## MEMORANDUM

**RE:** 1165R Mass Ave Apartments – Traffic Peer Review Comment Responses  
Nitsch Project #13990

**BUILDING 2 FIRST FLOOR  
VIEW #1**

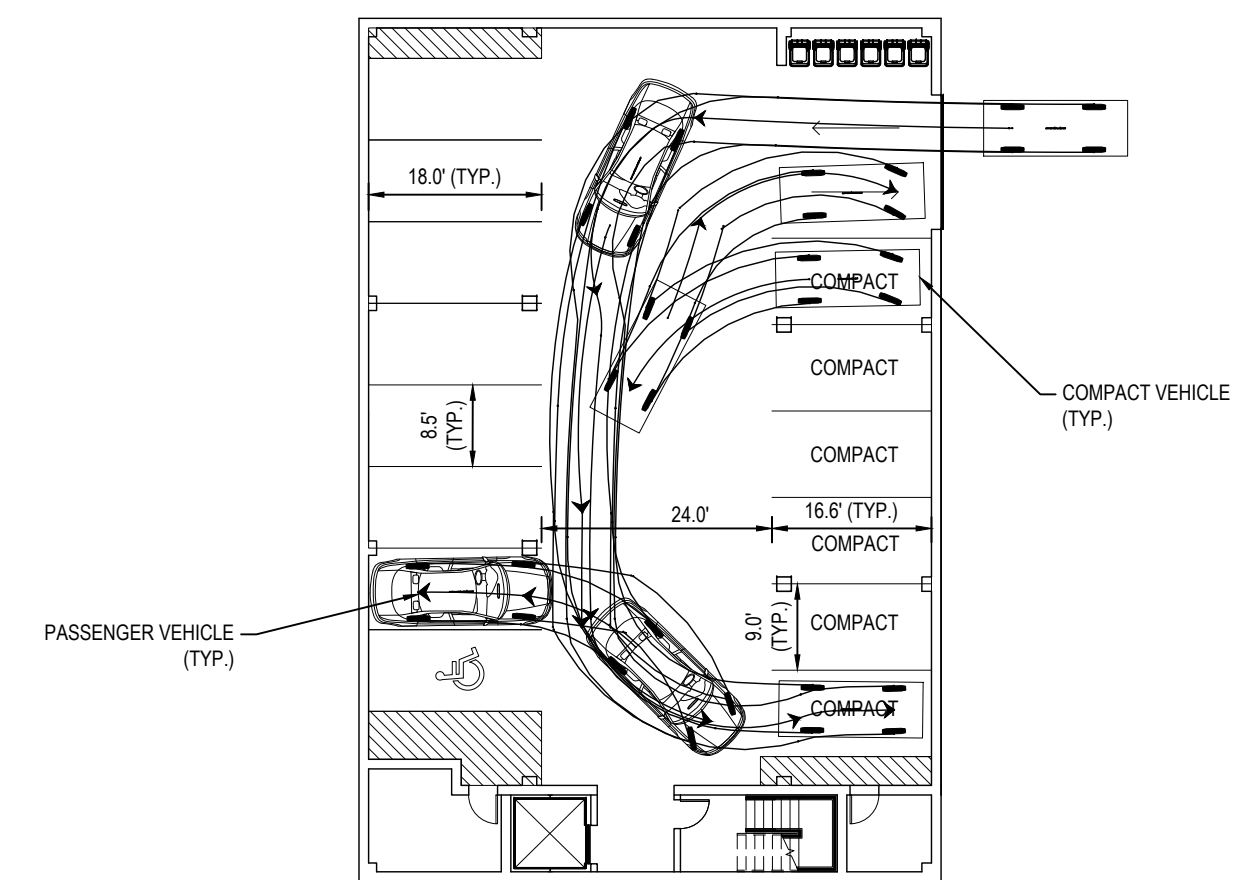
*T3a. The vehicle maneuver drawings suggest vehicles will strike support columns or walls, and will likely require vehicles to swing into adjacent parking spaces to adequately make a parking maneuver. A waiver to reduce aisle width is not recommended. Recommend maximizing the aisle width to accommodate multiple point turns to access parking without striking other vehicles, columns, or walls.*

*T4a. See Response T3. Turning maneuver drawings suggest vehicles will strike support columns or walls, and will likely require vehicles to swing into adjacent parking spaces to adequately make a parking maneuver. The tight garage will require multiple point turning maneuvers to safely access a space. This is more severe for spaces adjacent to end walls as shown on the turning sketches.*

*Building 2 is shown to have 1 accessible space adjacent to an elevator. This is acceptable, but will require an awkward move to exit the space which may not be possible/easy depending on the physical restrictions of the driver.*

**R3a. The revised Garage Vehicle Turning Exhibit dated April 29, 2021, has been attached to this comment response letter for review. Two parking spaces have been removed from the previous plan, and compact spaces have been designated to allow for unobstructed access into parking stalls. Additionally, Building Floor Plans, dated April 22, 2021, have been attached to this comment letter and show all aisle widths a minimum of 24 feet wide. As shown, the cars can accommodate multiple point turns to access parking without striking other vehicles, columns, or walls.**

**R9a. The Garage Vehicle Turning Exhibit and Building Floor Plans have been revised to be consistent with each other and to show the accessible designated parking spaces. The Garage Vehicle Turning exhibit also shows the vehicle turn into the accessible space in Building 2 next to the elevator.**
